MARK	DATE	DESCRIPTIONS	BY	CH'D	CCO#
0	05/17/11	SKYWAY BIKEPATH RAILING MODIFICATIONS	JD	TH	179

SAN FRANCISCO OAKLAND BAY BRIDGE
EAST SPAN SEISMIC SAFETY PROJECT

SKYWAY CLEANUP ITEMS

BIKEPATH DIVIDER RAIL CONDUIT ROUTING

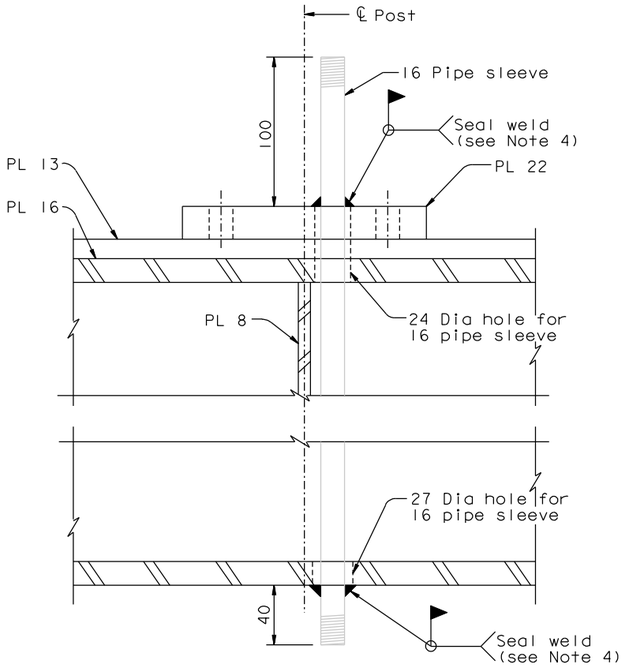
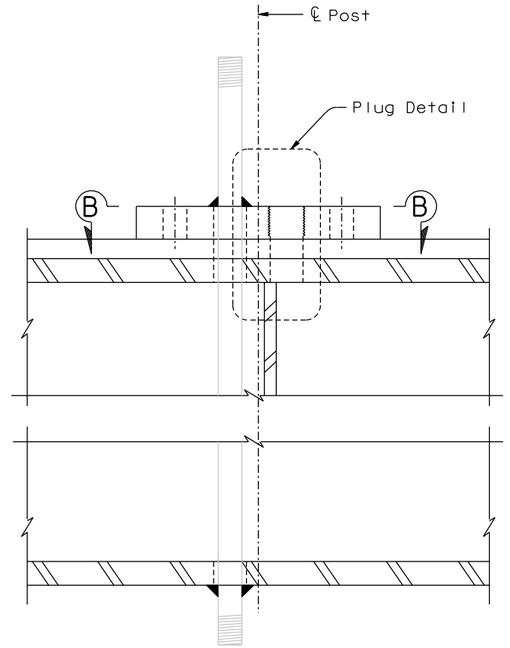
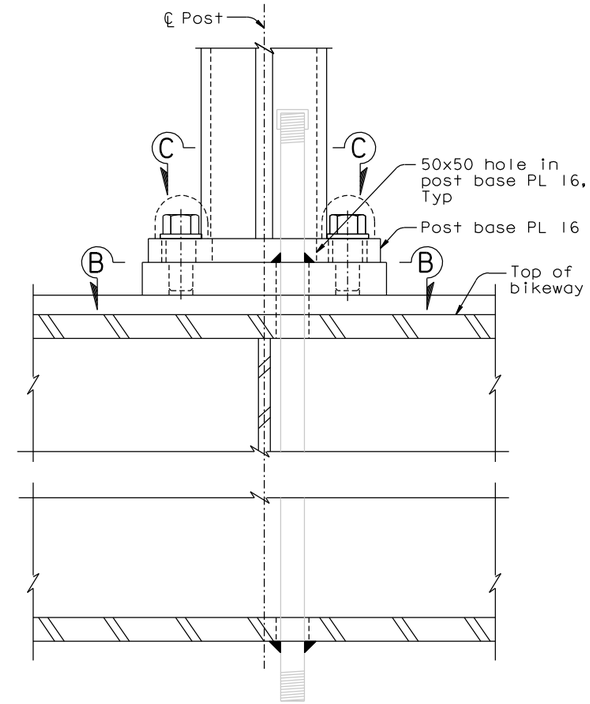
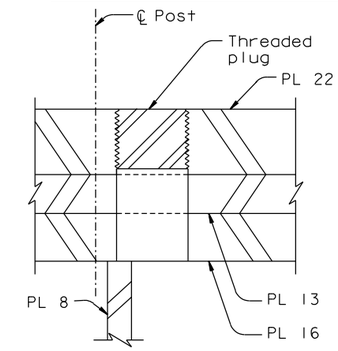
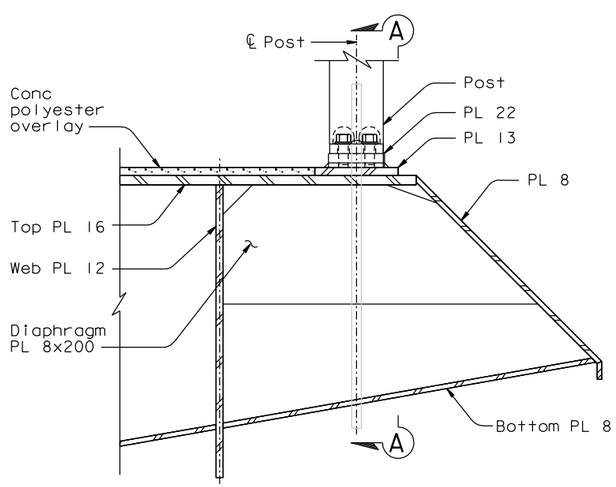
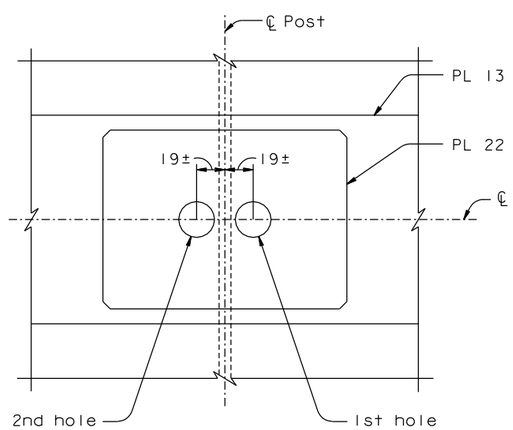
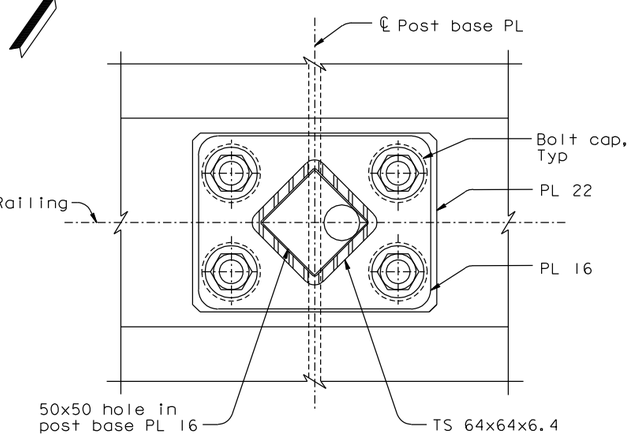
PROCEDURE FOR DRILLING EXPLORATION HOLES:

1. Mark the centerlines of the post and the railing on the PL 22, prior to removal of railing divider.
2. Remove bikepath railing divider @ panel joint by removing bolt caps, bolts and all shims.

3. Drill a 24 mm (15/16") hole through the PL 22, PL 13 and Top PL 16 and centered 19± mm east of the centerline of the post base PL. If no obstruction is encountered, drill a 27 mm (1-1/16") hole through the Bottom PL 8.

4. Install pipe sleeve and seal weld to top and bottom plates. Galvanized surfaces shall be repaired after seal welding. Areas with damaged paint or with no paint shall be cleaned and painted. Go to step #9.

5. If obstruction is encountered, check the hole to establish the diaphragm location.
6. Move to 19± mm west of the centerline of the post base PL and repeat step #3.

7. At the conclusion of the day, all holes shall be temporarily plugged to the satisfaction of the Engineer.
8. Plug 1st hole using Plug Detail.
9. Cut 50x50 hole in post base PL 16.

10. Lower divider rail to check fit.
